PRELIMINARY PLAN OF SUBDIVISION No. 3 WINDSOR HILLS

PROPERTY OF
G. G. FRALIN
BEING TRACT No. 2, 19.39 ACRES ±, PARTITION OF GEO. GARST SR. ESTATE
SHOWING
PROPOSED STREET & LOT LAYOUT, ST. GRADES & SEWER
SITUATE NORTH OF GRANDIN ROAD, WEST OF MUD LICK CREEK
ADJOINING THE WEST CORP. LIMIT OF ROANOKE CITY,
ROANOKE COUNTY, VIRGINIA.

BY: C. B. MALCOLM & SON
VA. STATE CERT. ENGRS.
N.B. 516-1952
DATE: APR. 16, 1953
PLAN SCALE: 1"=100'

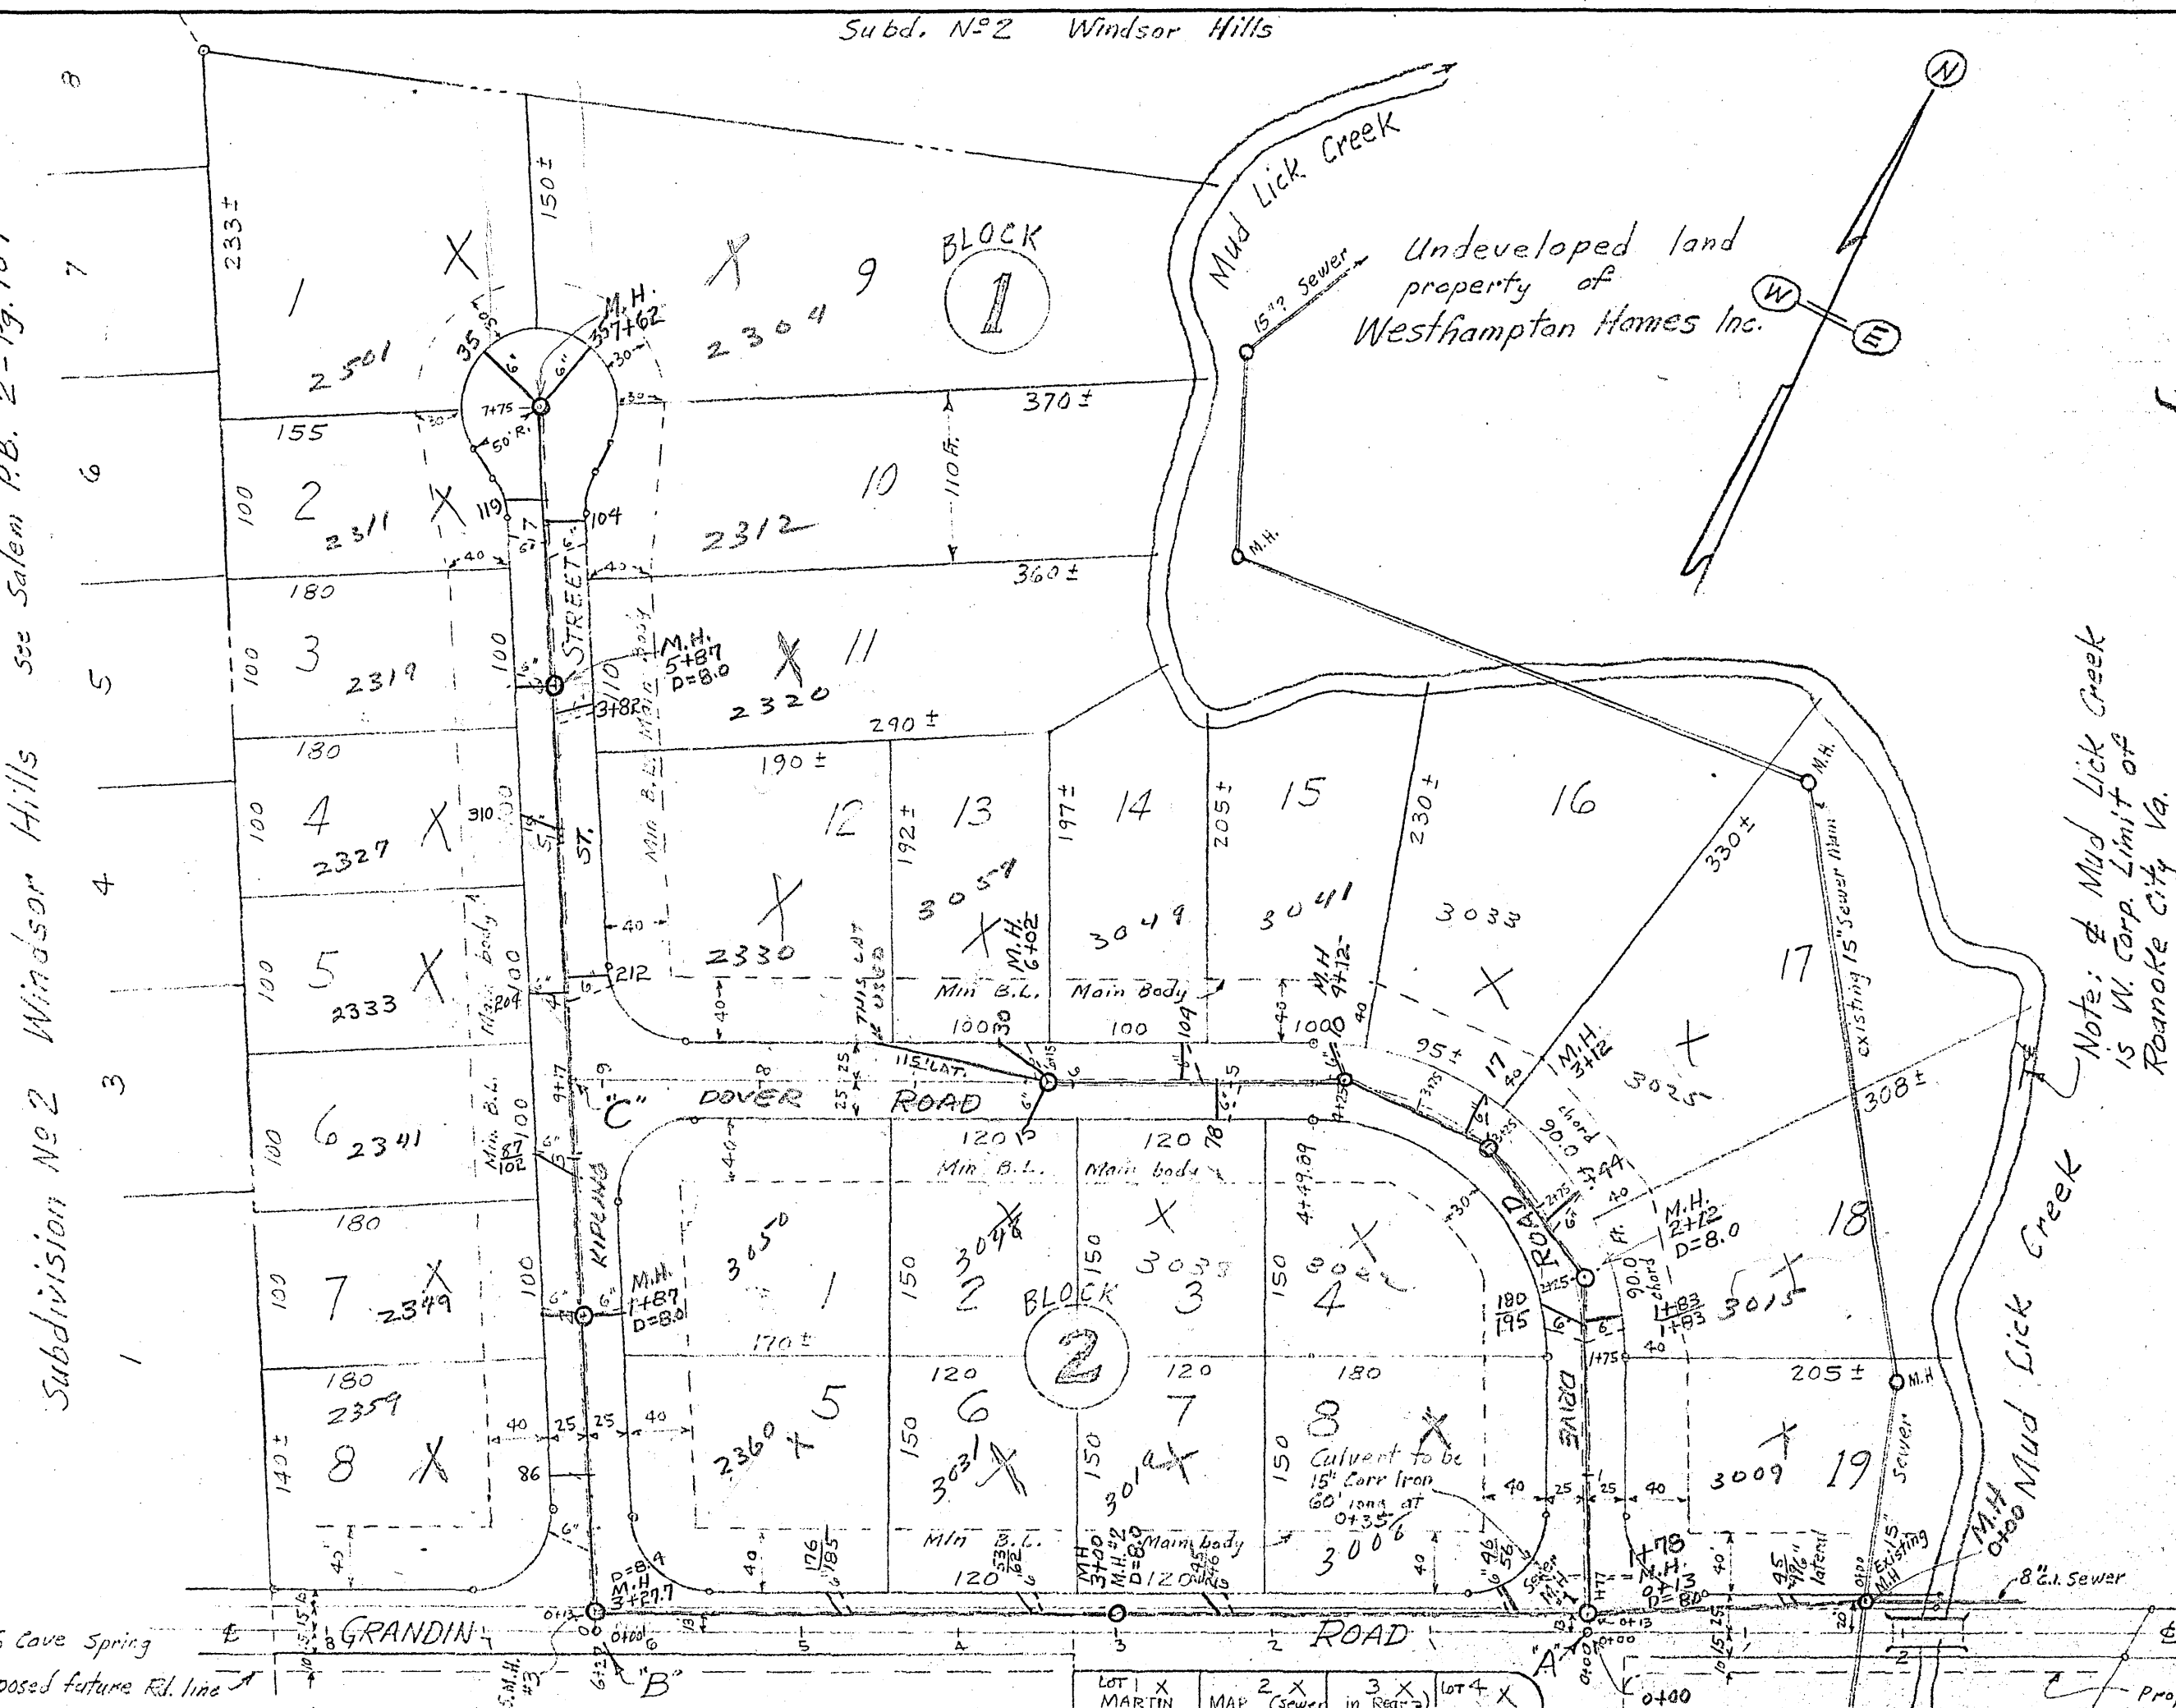
Subdivision Name? Street Names?
Subdivision No. 3, Windsor Hills?

Preliminary Sewer Estimate:
Grandin Road : 804' 8" T.C. Sewer, 3 Man Holes, 8' deep
"A" to "C" : 602' 8" T.C. Sewer, 4 Man Holes, 8' deep
B thru C to Circle: 662' 8" T.C. Sewer, 3 Man Holes, 8' deep
Total length = 2068' 8" T.C. Sewer, 10 Manholes, 8' deep
Average depth 8 ft.

Approx. 1700' of New Streets.
